**RE: The Wymont  
4315 Wyoming Blvd NE  
Grading and Drainage Plans  
Engineer's Stamp Date: 01/27/22  
Hydrology File: G19D004**

**RE: The Wymont  
4315 Wyoming Blvd NE  
Grading and Drainage Plans (G19D004)**

Per the correspondence dated December 27, 2021, please find the following responses addressing the comments listed below:

SHEET # GR-2

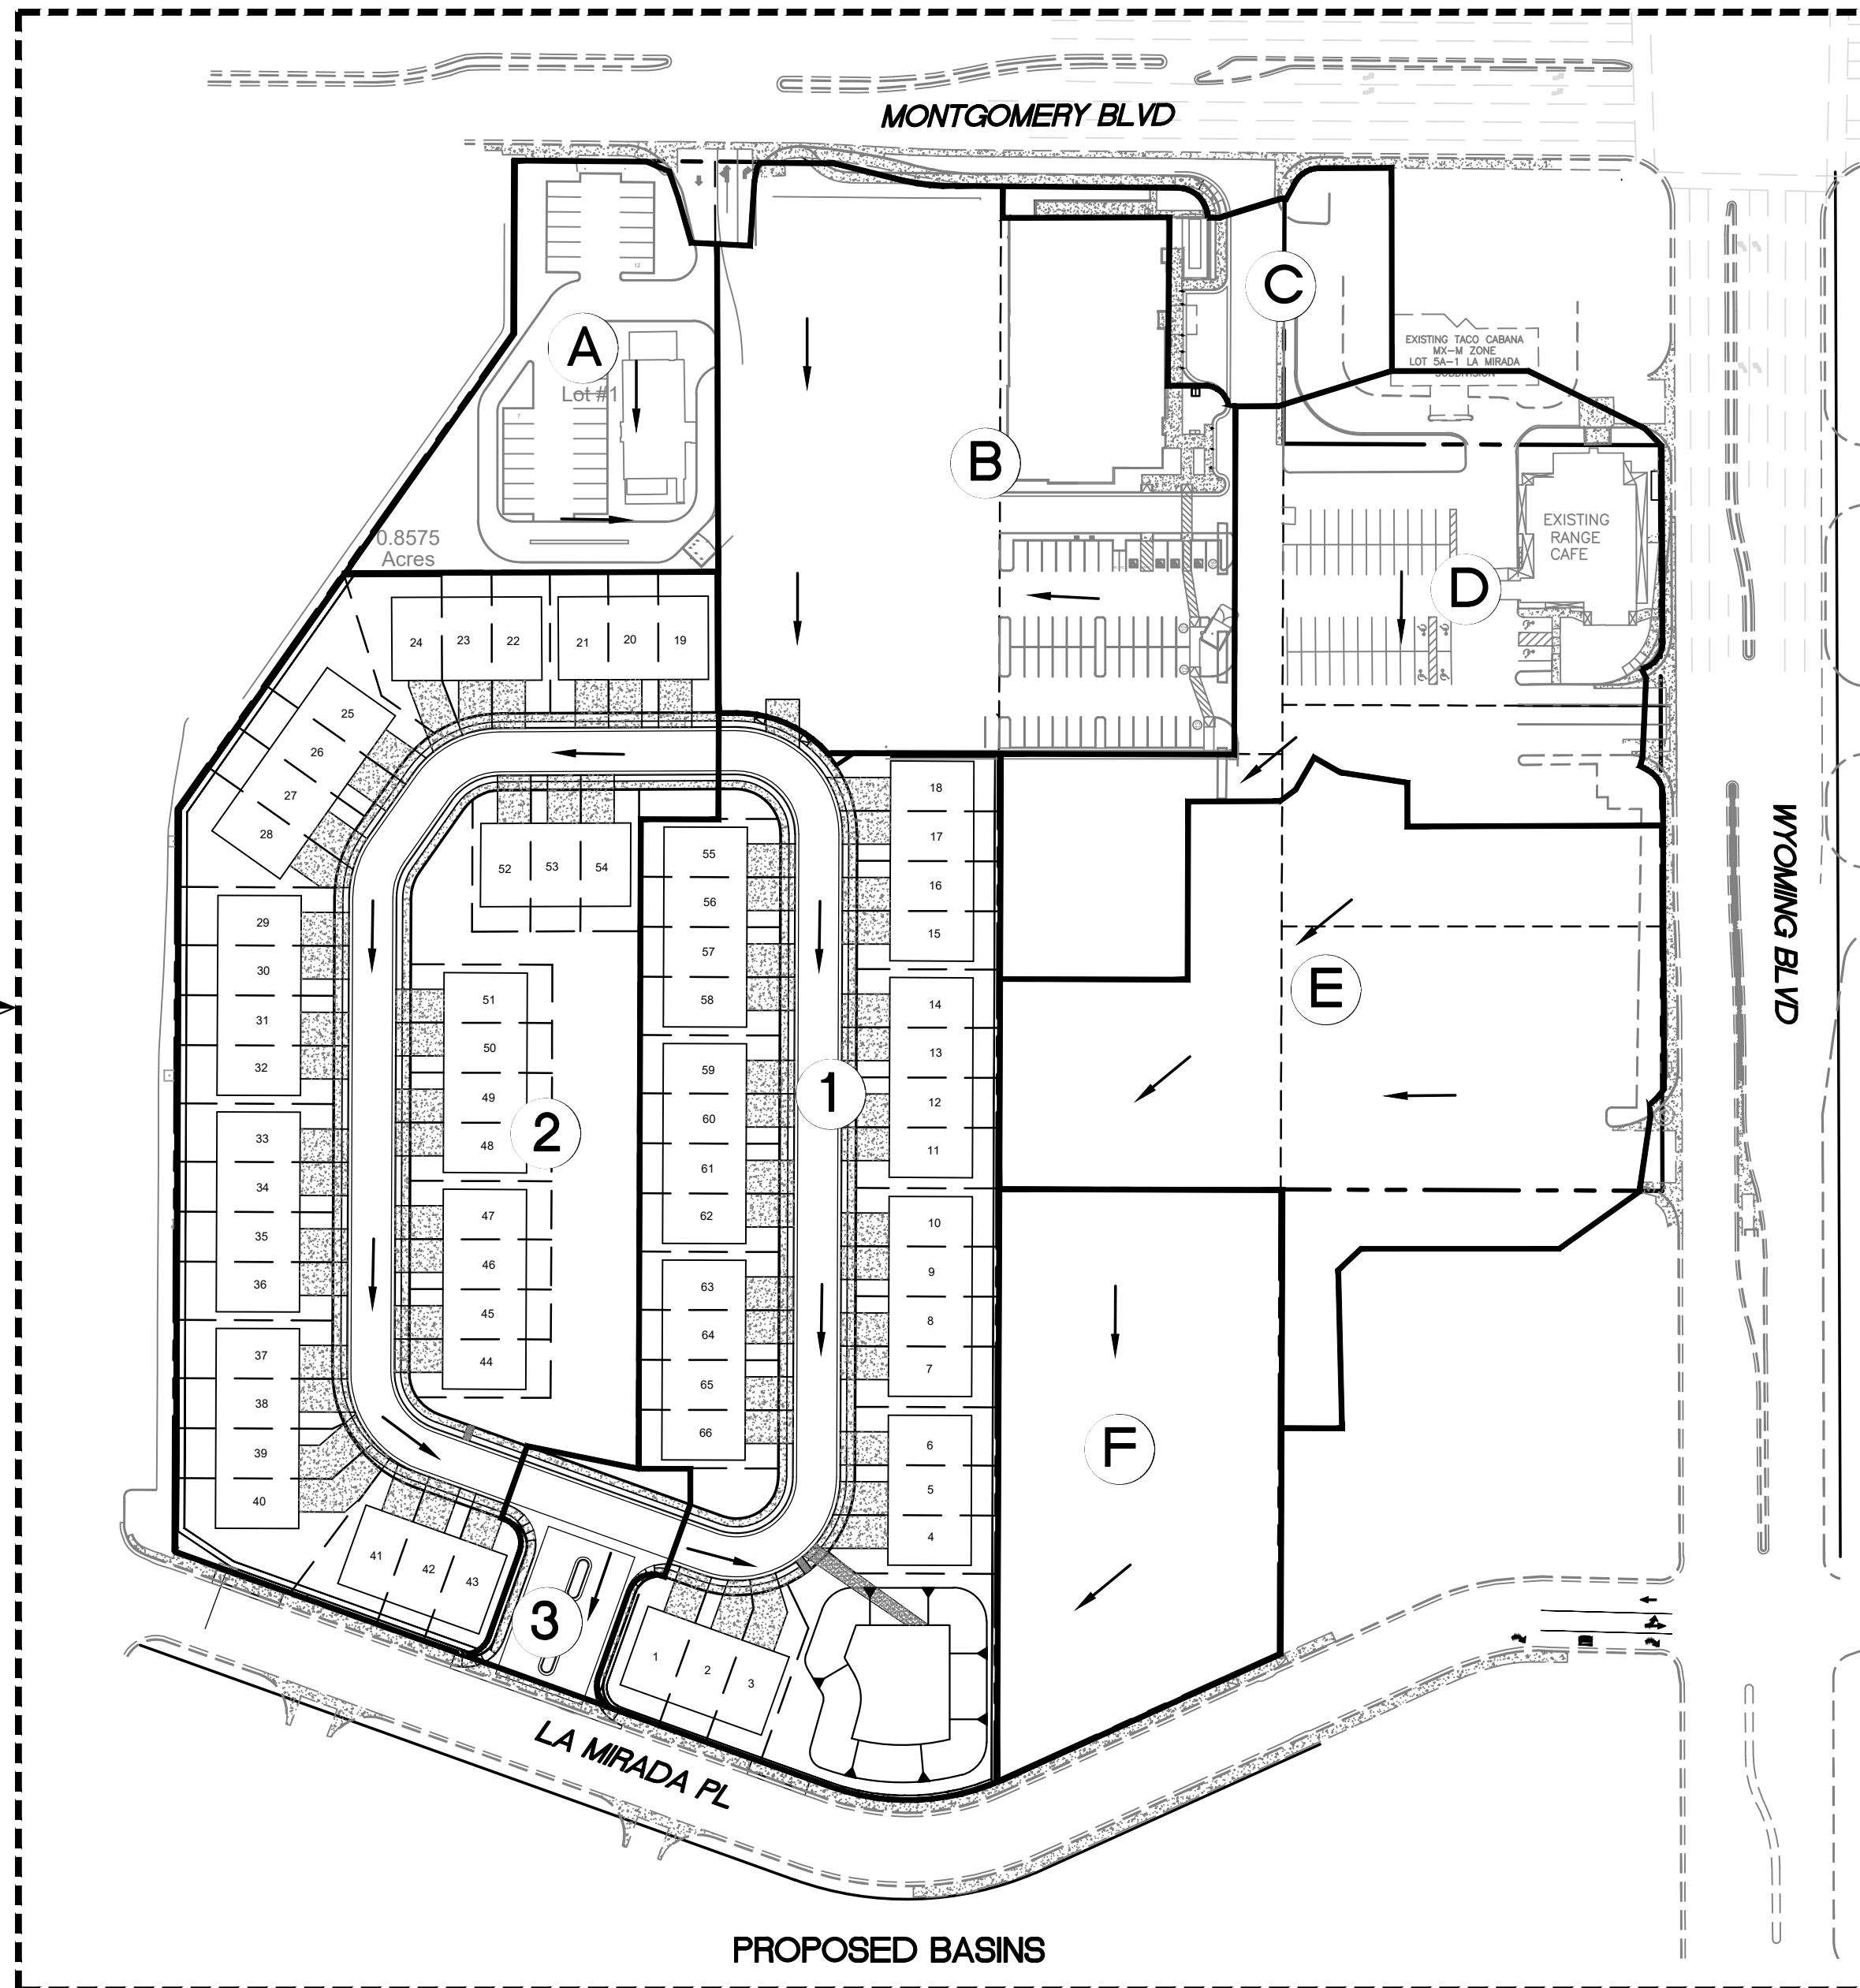
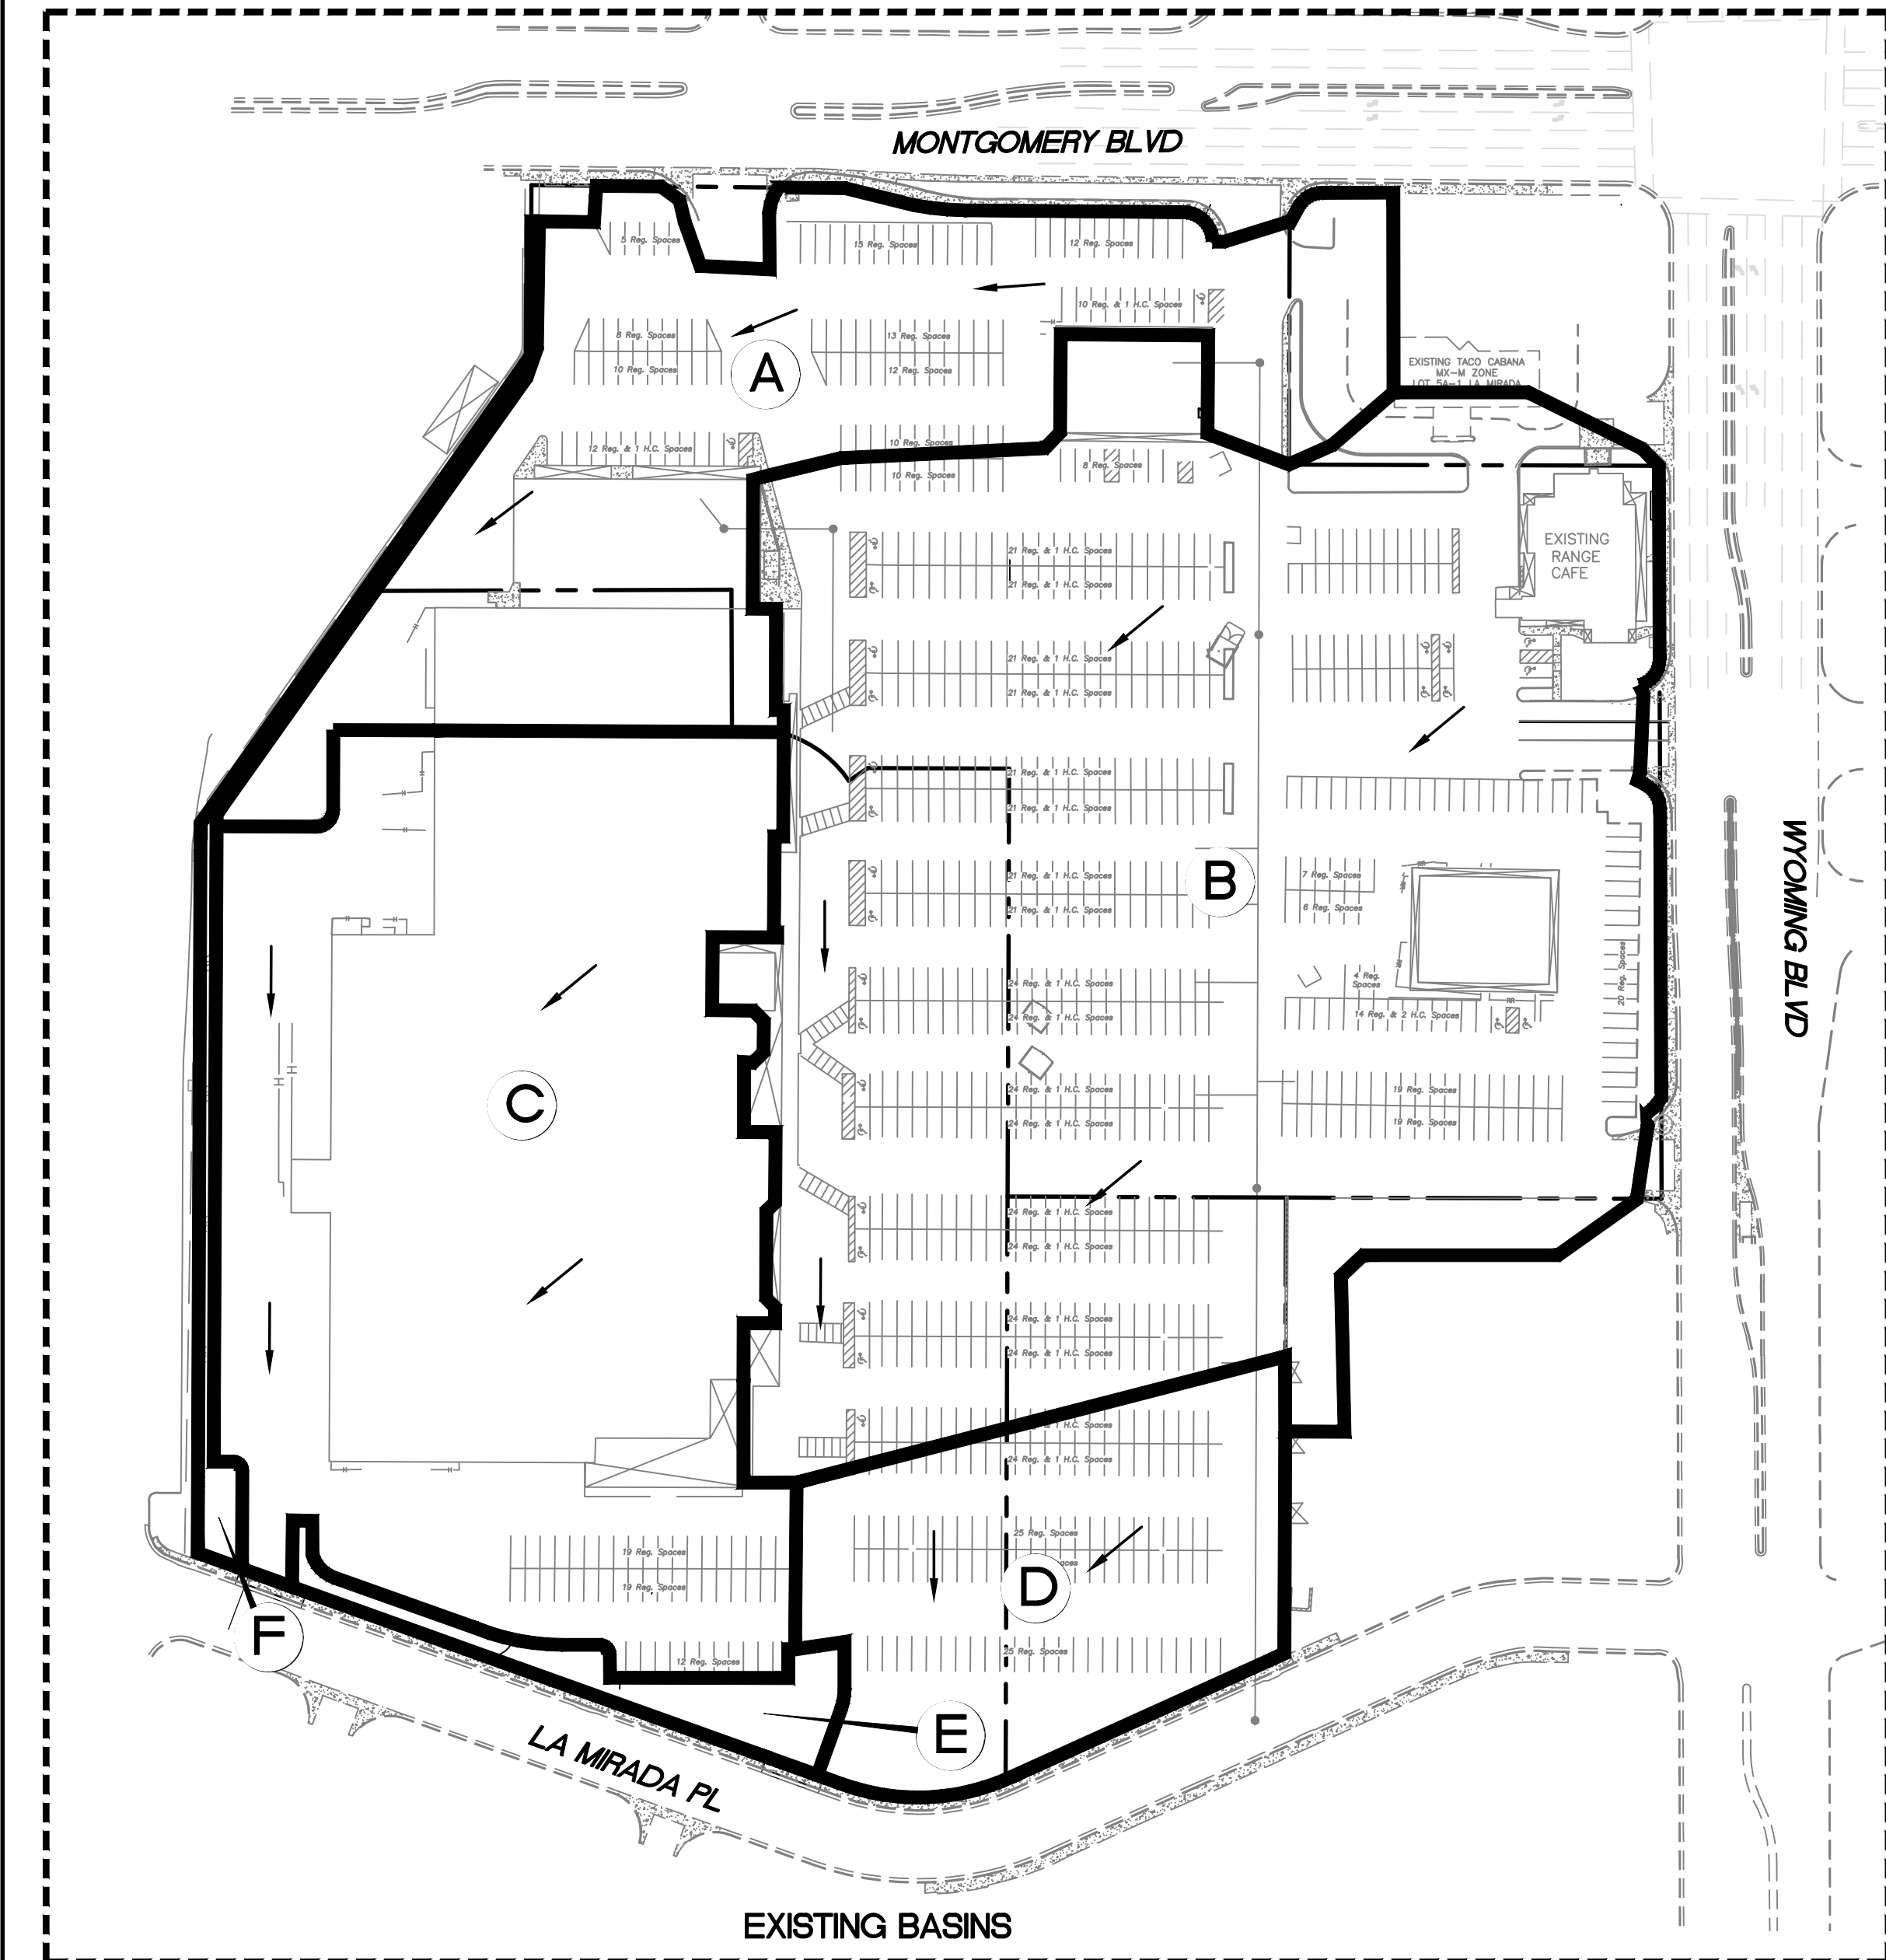
7. GR-3. Please relabel this as Master Drainage Plan. **This plan was retitled as the Master Drainage Plan.**

8. GR-3. The Existing Drainage Area "A" drains to the west and then to the southwest as was shown. The Proposed Drainage Area "B" goes to the southwest to a proposed inlet structure (to be built in the commercial work order) and the Proposed Drainage Area "C" does not drain to Montgomery as you tried to indicate but the area currently goes to the west as outlined in the Existing Drainage Area "A". So how does this drainage area get to the proposed detention pond to the south? **Flow arrows were added to the drainage plan to show direction of flow. Drainage Area "C" cannot drain to the pond due to site constraints and existing conditions. A Water Quality Waiver is included with this resubmittal.**

9. GR-3. There is a statement about providing for a volume of 0.225 AC-FT. Please provide the hydrology routing for the detention pond as outlined in the DPM Article 6-2 Hydrology. **A Pond Calculation Table was added to Sheet GR-4.**
